LOCATION ORMONT DRIVE

REPORT TO  
DELEUW CATHER, CANADA LTD

GEOTECHNICAL INVESTIGATION  
AND  
REVIEW OF GEOTECHNICAL DESIGN ASPECTS  
ORMONT DRIVE GRADE  
SEPARATION PROJECT

January, 1982

# SHEAR STRENGTH PROFILE

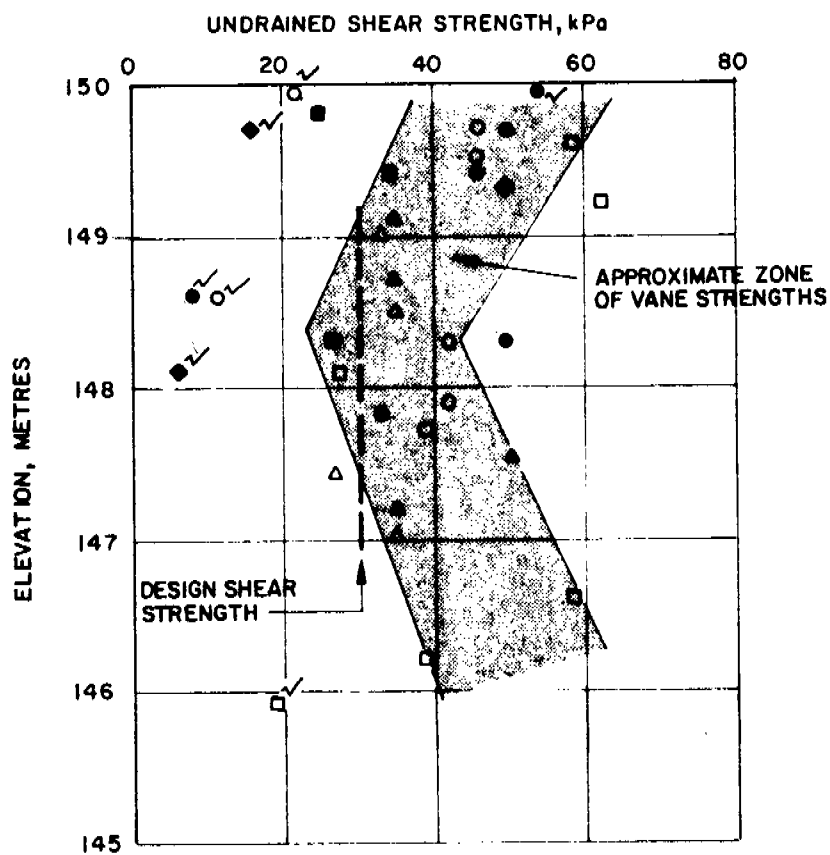
The results of both the in situ and laboratory strength tests have been plotted against elevation on Figure 5. It is apparent that the laboratory tests give significantly lower values of shear strength than those obtained from the in situ vane test. The clay material is of fairly low plasticity and although it contains occasional lenses of sand and silt it is felt that these are not of sufficient frequency to invalidate the vane test results. It is interesting that the laboratory test results give values close to the remoulded shear strength measured by the vane (refer to Record of Borehole (sheets)). This implies that the samples tested in the laboratory had experienced some disturbance and it is concluded that the vane strengths provide the best estimate of undrained shear strength of the deposit.

A zone representing the range of shear strengths measured by the vane tests is indicated on Figure 5. Although the zone is fairly wide it appears that the strength gradually reduces with depth to about elevation 148.5 m and thereafter starts to increase. This is consistent with a deposit in which the upper zone has been overconsolidated due to weathering while the lower material is only lightly overconsolidated and has properties which are a function of the overburden stress.

For short term loading a design undrained shear strength of 30 kPa has been selected for the clay layer (Figure 5). This corresponds to about the lower quartile of vane strengths between elevations 149 and 147 m. Since the footings are from 3 to 4.75 m wide it is this layer which will have the most influence on the bearing capacity of the clay.

The presence of a cohesive intercept is normally associated with overconsolidation and reference to the undrained shear strength plot (Figure 5) suggests that between elevation 149 and 147 m this may reduce to zero. The long term analysis has therefore been carried out for two cases. The first assumes  $c' = 0$  and  $\phi' = 25^\circ$  which gives an overall shear strength approximately equal to that measured. The second case is considered to be a lower bound and assumes  $c' = 0$  and  $\phi' = 22.5^\circ$ .

# CONDITIONS FOR EARTH PRESSURE CALCULATIONS

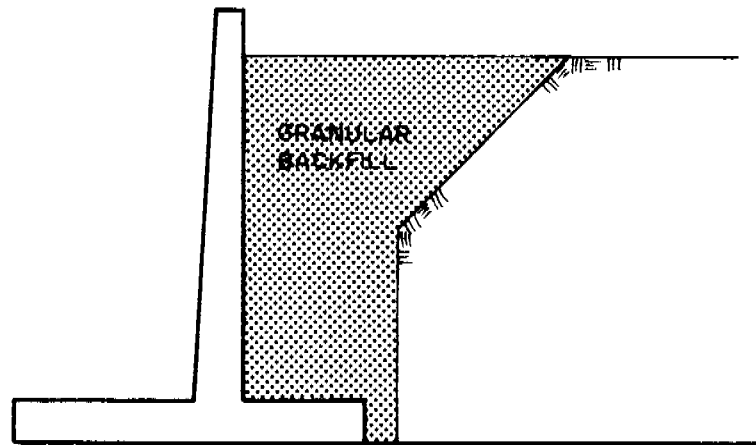
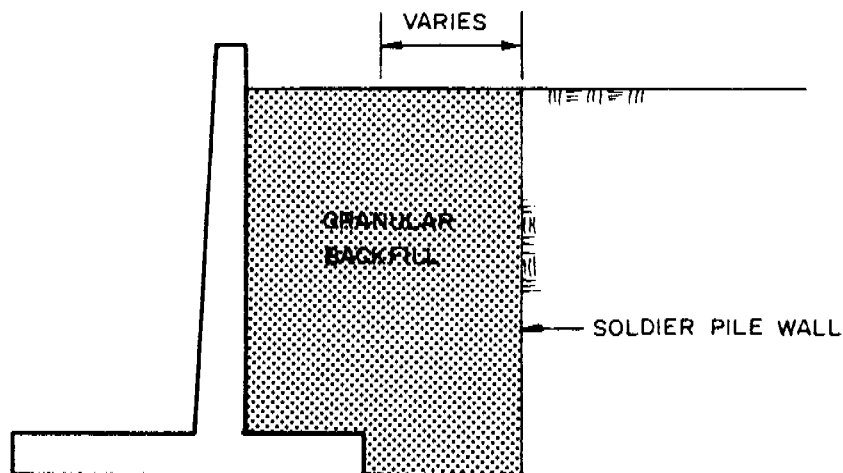
For the Ormont Drive retaining walls the contract drawings indicate backfill to extend only to a vertical line close the back of the footing. The contractors shoring details, (S. McNally & Sons Ltd. Drawing No. C-246-3) show the soldier pile wall to be further back from the proposed retaining wall than indicated on the contract drawings. There is therefore greater space for granular backfill to be placed and this would have an effect on the earth pressures. It is understood that some discussions are taking place on the acceptability of the soldier pile wall in the position indicated. Calculations of earth pressure have therefore been made for two conditions (Refer to Figure 8):

- a) "Design Condition" in which backfill extends only to a vertical line from the back of the retaining wall footing.
- b) "Assumed As-built Condition" in which specified granular backfill extends to soldier pile wall as indicated on S. McNally & Sons Ltd. Drawing No. C-246-3.

# LONG TERM PORE PRESSURES IN CASE WHERE DRAINAGE IS DESIGNED TO AVOID HEAVE OF ROAD

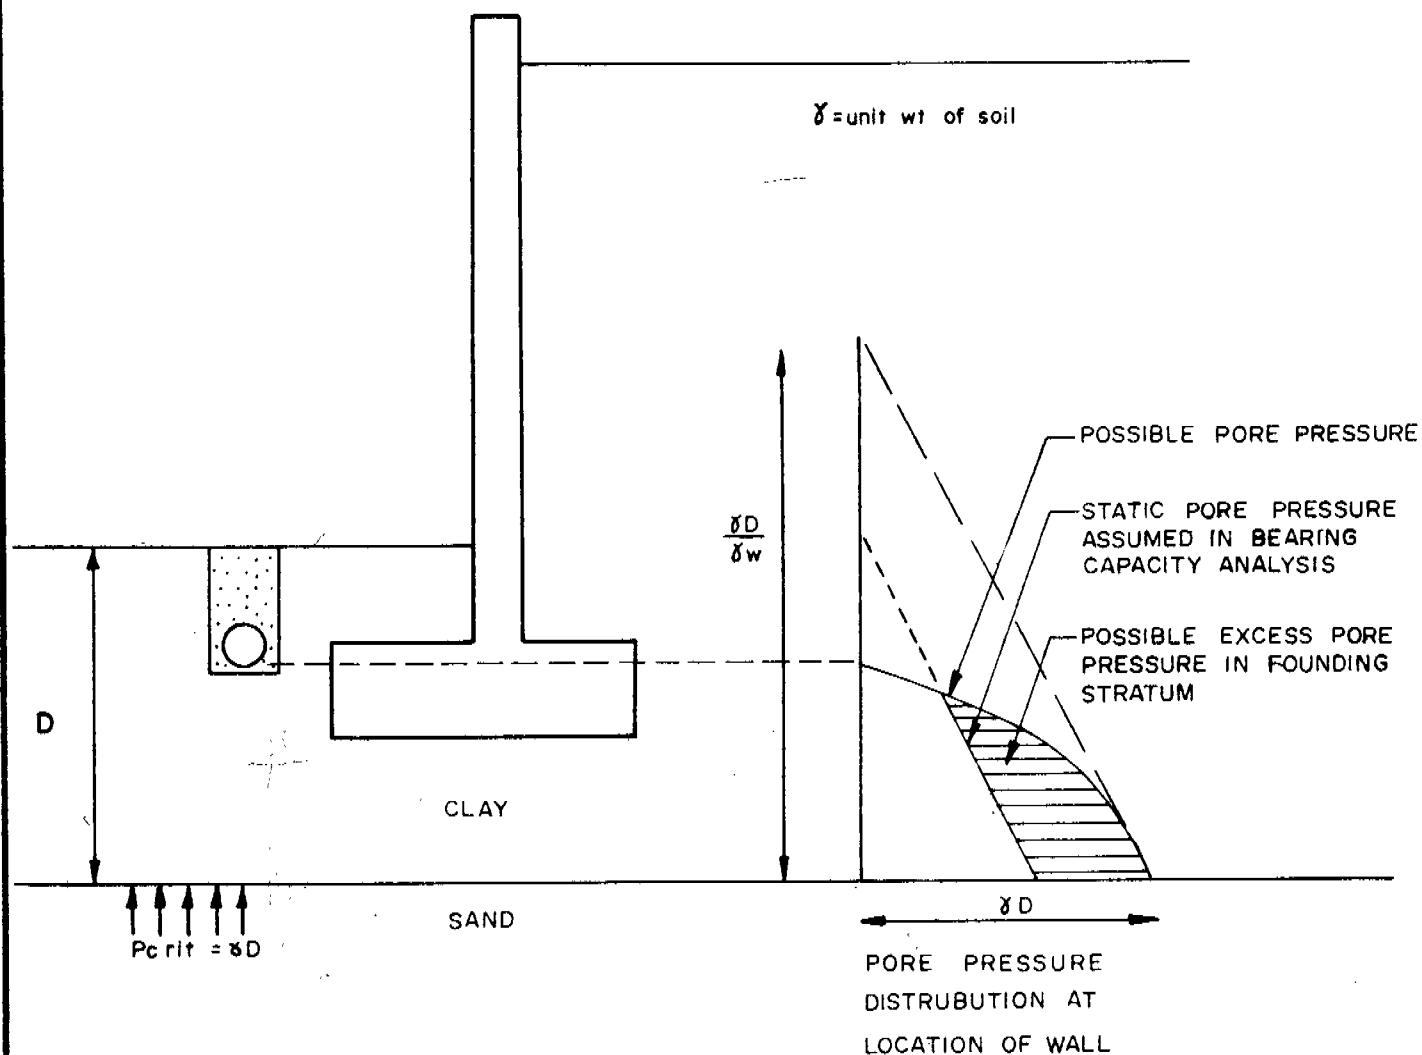
All stability analyses carried out are extremely sensitive to the assumed groundwater pressures. The potential for long term excess pore pressures has been discussed in our report 811-1376 (refer to Figure 9 of that report). It is recommended that the permanent road drainage is reviewed in the light of the pumping test carried out by Trow Ltd. to ensure that drawdown will be to at least the finished road level. In the temporary condition, the pressure in the underlying soil must be maintained below the base of the excavation at all times, without any potential for upward seepage.

SECTIONS ALONG NORTH AND SOUTH RETAINING WALL ALIGNMENTS FIGURE 3

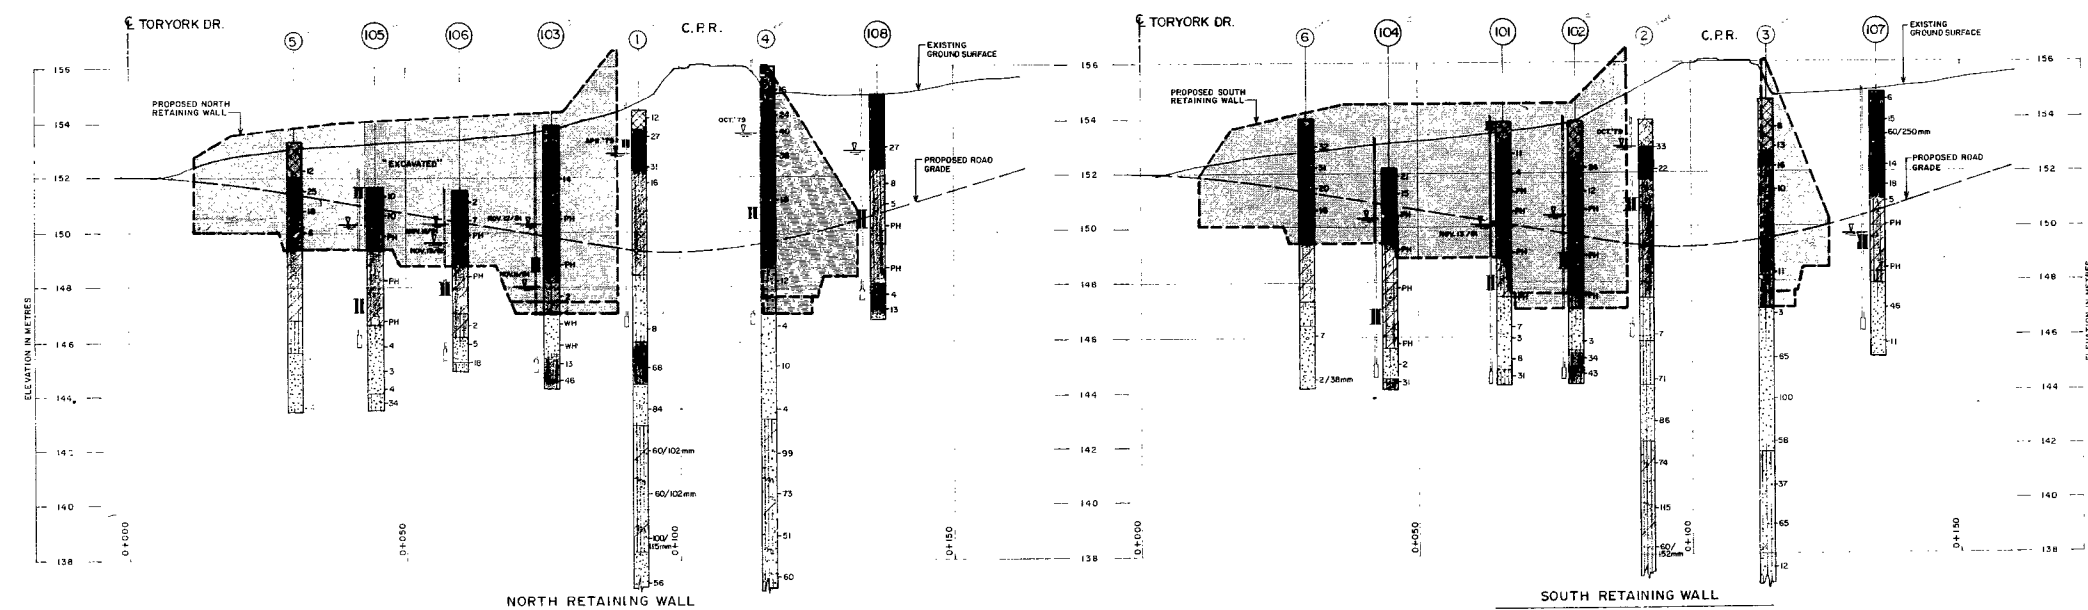
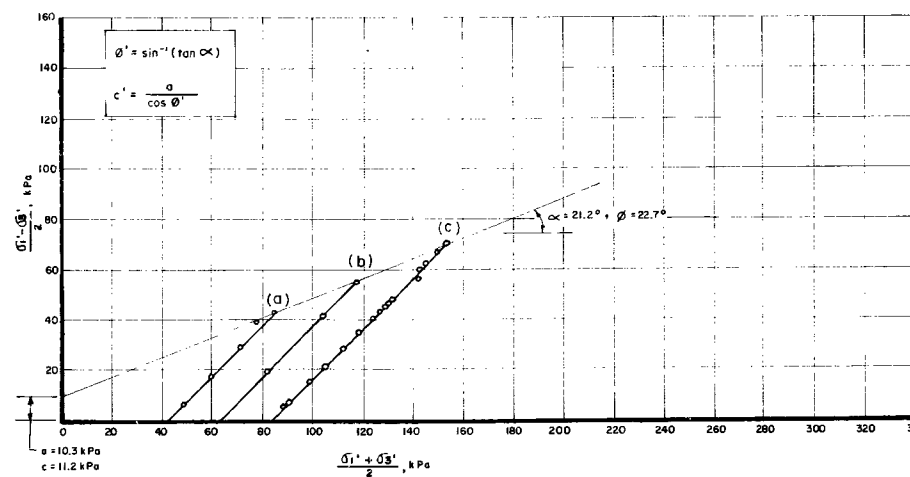
Groundwater levels recorded in the standpipes are indicated on the Record of Borehole sheets and in the stratigraphic section (Figure 3). Prior to commencing the excavation the contractor had proceeded to lower the water level in the sand aquifer and the levels recorded are significantly below the level of about 153 m recorded by Trow Ltd. in 1979. It is worthy of note that the groundwater conditions recorded in the present investigation are temporary and do not necessarily reflect those which will be established during the working life of the underpass.

Footing elevations along the wall vary from 147.3 m for the high wall adjacent to the bridge to 150.0 m at Toryork Drive (Figure 3). Apart from the high walls (Panels N-G, N-H, N-K, S-D, S-C and S-B) which are founded in the loose silt all the walls are founded in the overlying firm to stiff clay.
